Docket Number:	79-AFC-01C
Project Title:	Compliance - Application for Certification for PG&E Geysers Unit 17 (78-NOI-3)
TN #:	214572
Document Title:	Notice of Determination - Petition to Amend the Final Decision for the Lakeview Geothermal Project
Description:	Notice of Decision Lakeview Geothermal Project
Filer:	Bruce Boyer
Organization:	California Energy Commission
Submitter Role:	Commission Staff
Submission Date:	11/29/2016 8:15:36 AM
Docketed Date:	11/29/2016

NOTICE OF DETERMINATION

PETITION TO AMEND THE FINAL DECISION FOR THE LAKEVIEW GEOTHERMAL PROJECT (79-AFC-01C)

ENVIRONMENTAL JUSTICE POPULATION FIGURE

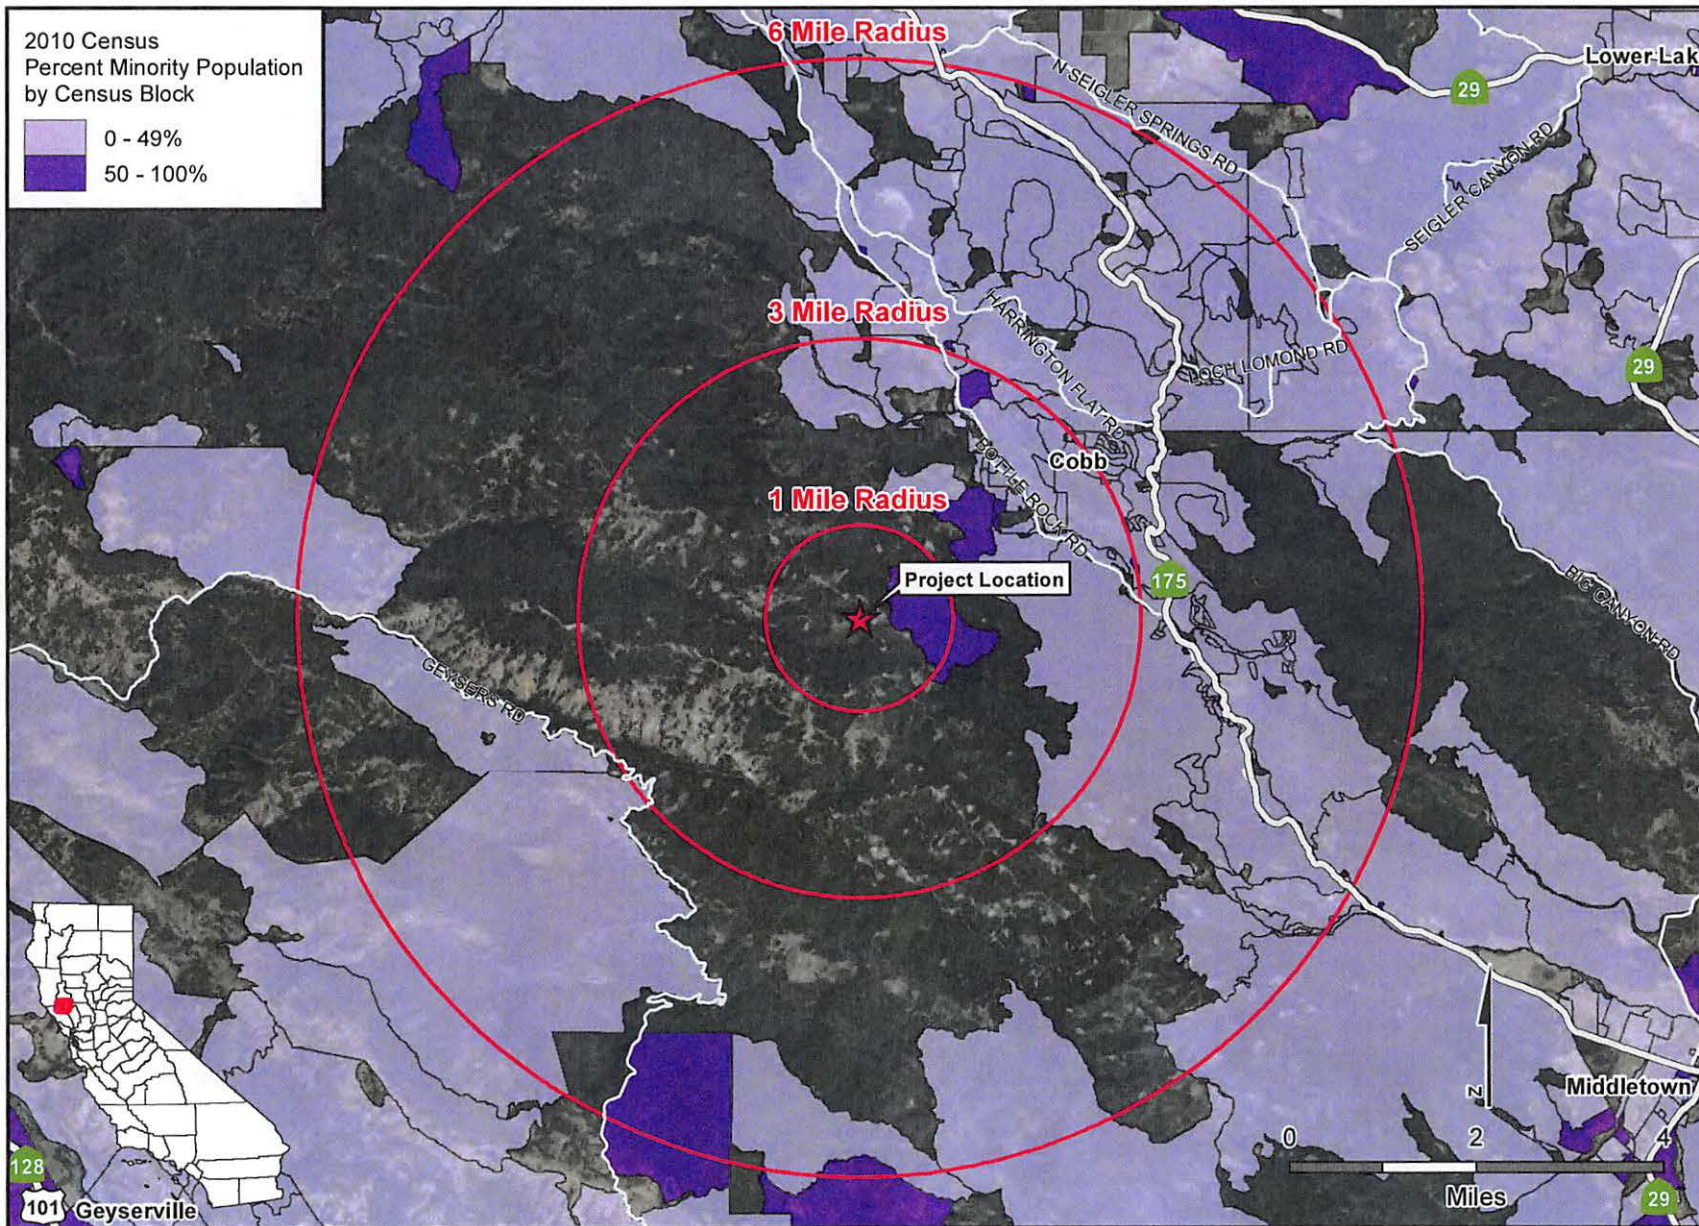
The **Environmental Justice (EJ) Population Figure** shows 2010 census blocks in the six-mile radius of Unit 17 with a minority population greater than or equal to 50 percent. The population in these census blocks represents an EJ population based on race and ethnicity as defined in the Council on Environmental Quality's *Environmental Justice: Guidance Under the National Environmental Policy Act*.
